LAKE HAVASU CITY, ARIZONA
ADMINISTRATIVE SERVICES DEPARTMENT
◆ PROCUREMENT ◆

**INVITATION TO BID
NEW LABORATORY BUILDING REBID
PROJECT NO. B26-PW-107032-500739
ADDENDUM NO. 3
DECEMBER 10, 2025**

Lake Havasu City Typical Drawing Trash Enclosure

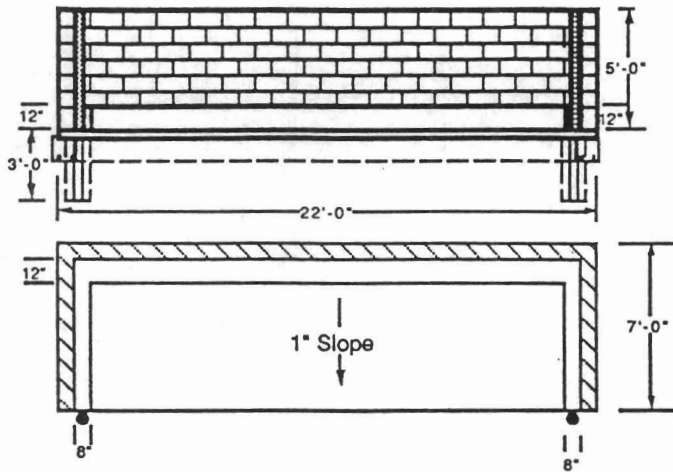
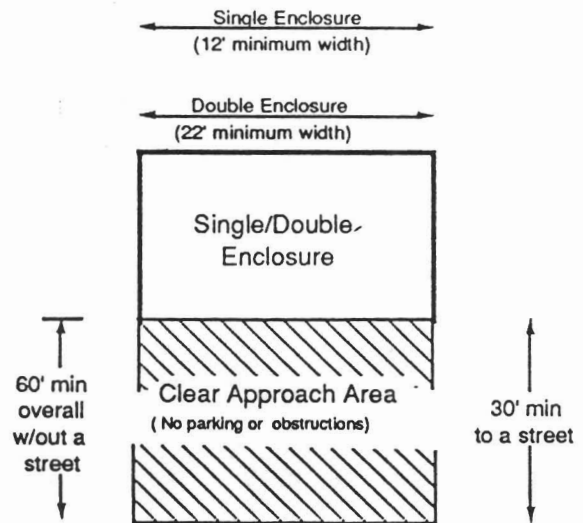
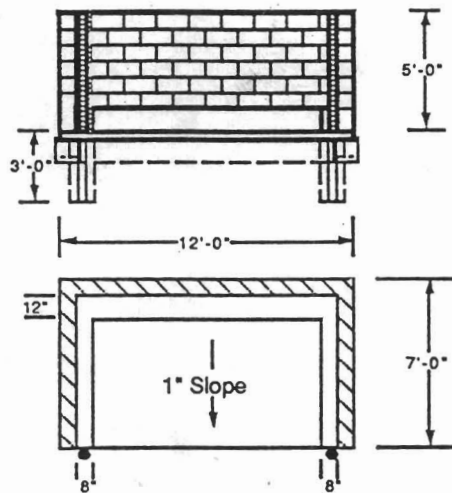
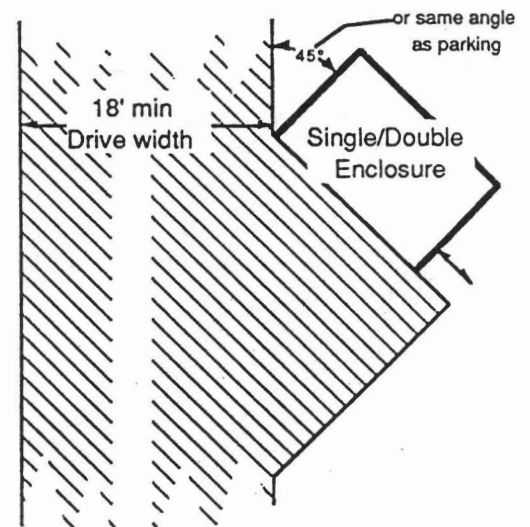
Question 17: For trash enclosure detail can you provide the foundation details for the trash enclosure slab and footings to include concrete thickness, depth of footings, and reinforcing steel requirements. Also, what are the requirements for the gates, can you provide an elevation. Is the optional gate required for this project?

Answer 17: Please see attached detail (Attachment A). Yes, the gate is required.
